DATE: FEBRUARY 12, 2013 SERVICE BULLETIN #20121106 - REV 1

SUBJECT: "Reserve Staging Loop" with support washer. We (manufacturer) require the washer be removed. At the next scheduled repack cycle, remove the washer from the bungee staging loop and tie a double over-hand knot as instructed below and reinstall.

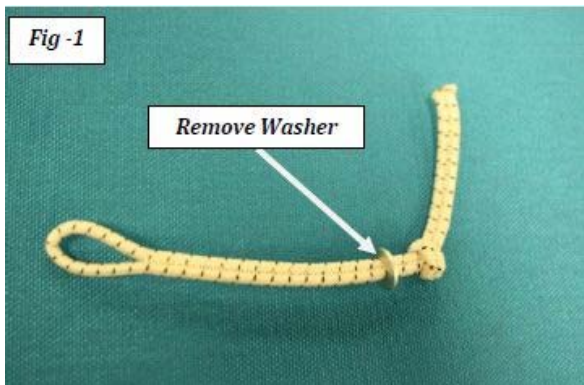
BACKGROUND: During recent inspections prior to repacking the reserve, extra normal wear was found on the reserve closing loop. Further investigation indicates that Vector systems fitted with a (bungee) "Reserve Staging Loop" with support washer may experience this problem. Some washers have sharp edges which had caused minor damage to the closing loop. Thus far, loop damage seen in the field following a 365-day repack cycle has not been considered serious, but is a concern. This Product Service Notification provides a safe solution without altering the function of the staging loop.

SERVICE BULLETIN: At the next scheduled inspection/repack cycle remove the support washer from the "Reserve Staging Loop." (Fig-1) Inspect the internal and external condition of the staging loop and replace it if any damage is found. Tie a "Double Over-Hand Knot" at the prescribed location. The staging loop length should be 1-inch (25mm) shorter than the reserve closing loop. Mark the loop at the desired length. Fig-2 shows a single over-hand knot. Fig-3 shows the loop end passing one more time through to create the double
